## TECHNICAL BULLETIN: TB15-03

Issue Date: March 2015

Pro Series/Reese Select Series 5<sup>th</sup> Wheel: Service and Inspection Recommendation

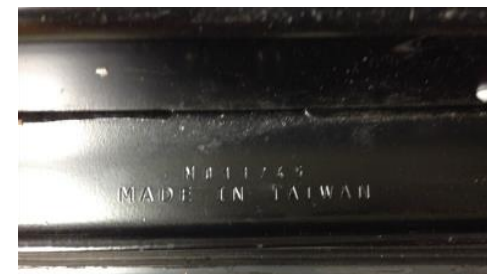
A. Units with MFG build date 2012 thru 2014 are suspect if they have:

- MFG Date Codes between M011201 – M011431

- The C-clip design shown here

B. Units with MFG Date codes M011200 – M011431 are **OK** if they have either:

- A green dot or blue paint mark on the head assembly

- The updated C-clip design

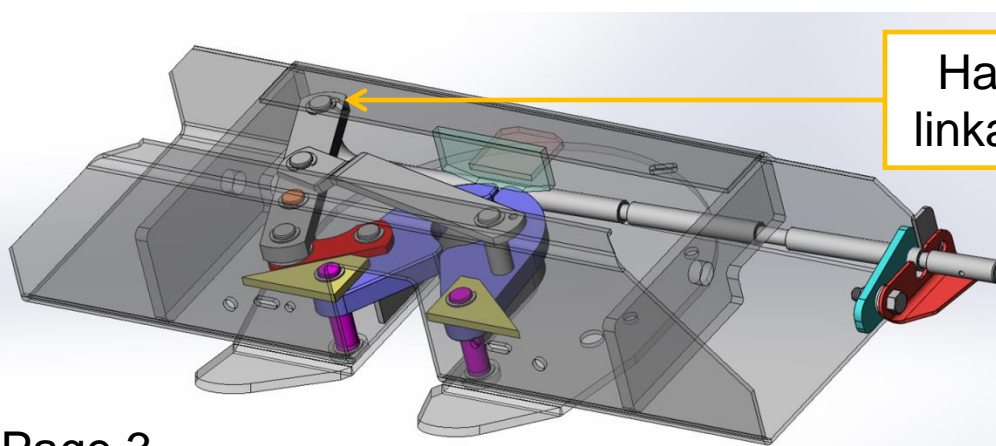
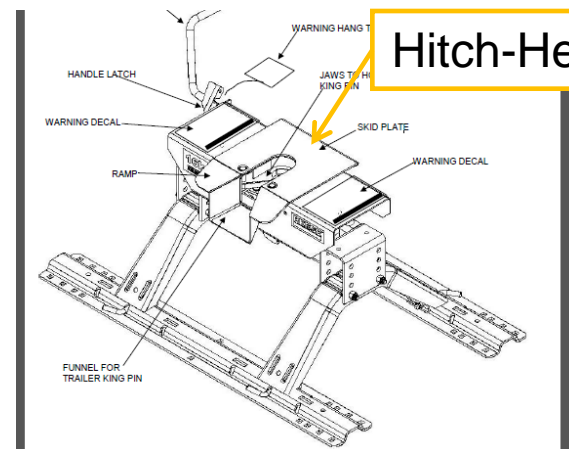
- A. Remove the 5<sup>th</sup> Wheel Hitch – Head
- B. Lay on workbench upside down
- C. Inspect C-Clip to see if it is installed correctly at the handle to linkage joint (see page 4). *If installed correctly: the C-Clip will be at the prescribed location and will rotate by hand or screw driver force.*
- D. If the C-Clip is missing or not installed correctly, contact Reese (ph. 800.632.3290) for service kit 58526. Disconnect handle as identified below and install replacement C-Clip. **Warning: do not use or sell prior to replacing C-Clip!**
- E. Service Kit: C-Clips will have colored paint dot on clips.

Handle to  
linkage joint

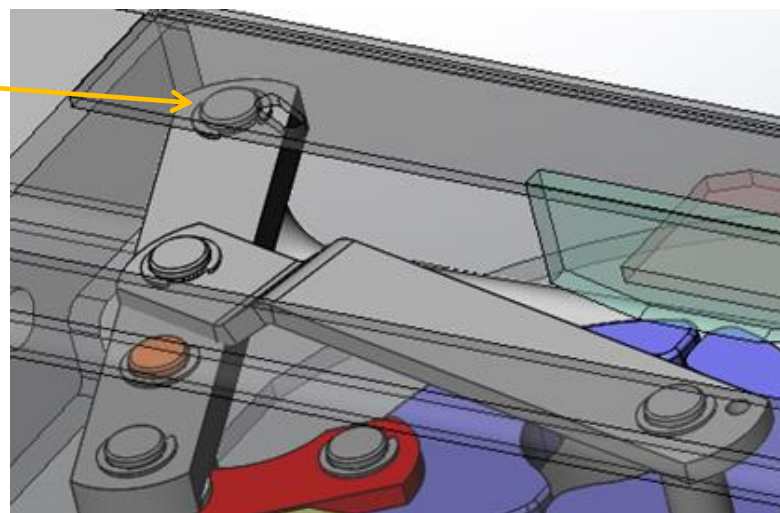
### Criteria for a correctly installed C-Clip:

#### A. C-Clip wings are in the groove

#### B. C-Clip base is in the groove

#### C. Secondary verification:

Confirm that C-Clip rotates by hand or screw driver force.
